UNITED STATES PATENT AND TRADEMARK OFFICE

APPLICATION NO.	FILING DATE	FIRST NAMED INVENTOR	ATTORNEY DOCKET NO.	CONFIRMATION NO.
09/830,512	04/25/2001	David F. Dawson-Elli	DAWSON-ELLI6	8188

Office Action Summary

DETAILED ACTION

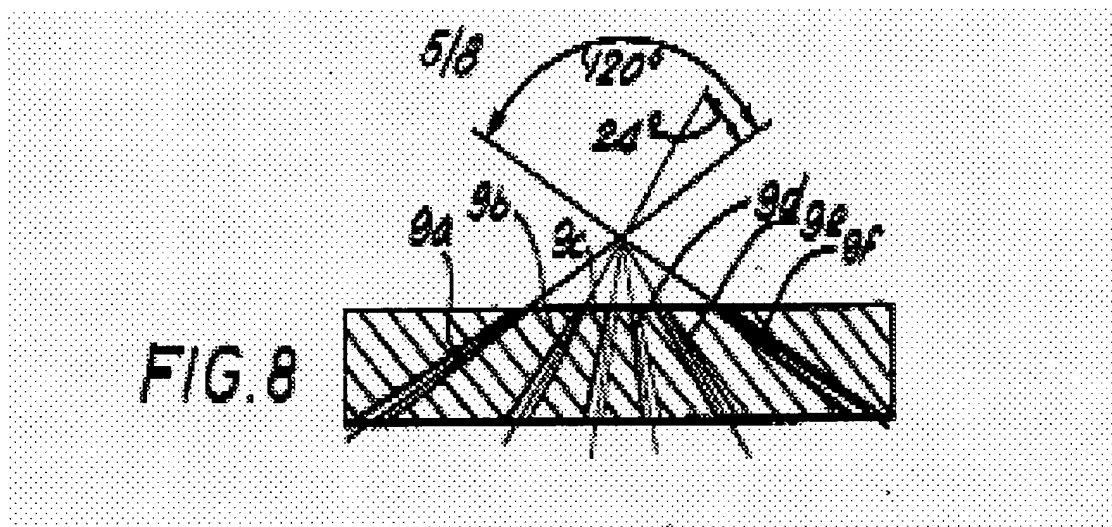
Bartels et al. disclose and show (figures 3,3a, 3b, 8,12,13) various manifolds including a plurality of converging passages with a plurality of inlets and a plurality of outlets wherein the fluid passages have a smaller cross section at the fluid outlets than at the fluid inlets. Bartels et al discloses “slitted”, “square”, “round” and “ very narrow or flat nozzle openings” as suitable cross-sectional nozzle shapes. In regard to claim 4, the “slitted” and “ very narrow or flat nozzle openings” are deemed the structural and functional equivalent to applicant’s “slot-shaped” fluid passage outlets.

“FIG. 3 shows part of a nozzle assembly 36 in which the two-stage filter 37, 38 and the five parallel channels 35 generally correspond to the filter 27, 28 and channels, 25 of the embodiment shown in FIGS. 2/2a. The nozzle outlet 24 according to FIG. 2 is, however, replaced here by the twin nozzle outlet 39a/39b. As can be seen from the enlarged drawing in FIG. 3b, the twin nozzle outlets 39a/39b direct two jets at an angle of 90.degree relative to each other. Due to the collision of the jets, particularly good atomization is obtained. The twin nozzle outlets can be modified in various ways. Thus, both jets can, if so desired, be oriented towards each other at a more acute angle or at a more obtuse angle (about 20.degree. to 160.degree., preferably 60.degree. to 150.degree. and more preferably 90.degree. to 120.degree.). **In addition the cross-section of the nozzle outlets can be selected differently; for example the strong tapering of the outlets 39a/ 39b in FIGS. 3, 3a, may be dispensed with. As illustrated in FIGS. 3b, it is desirable for the jets to impinge a slight distance away from the nozzle outlets.** Smaller orientation deviations do not then result in incomplete collision of the jets on one another. The edges of the structure may be beveled where long term use of the channel plate might cause breakages to the edges which could cause the filter or nozzle to become blocked.”
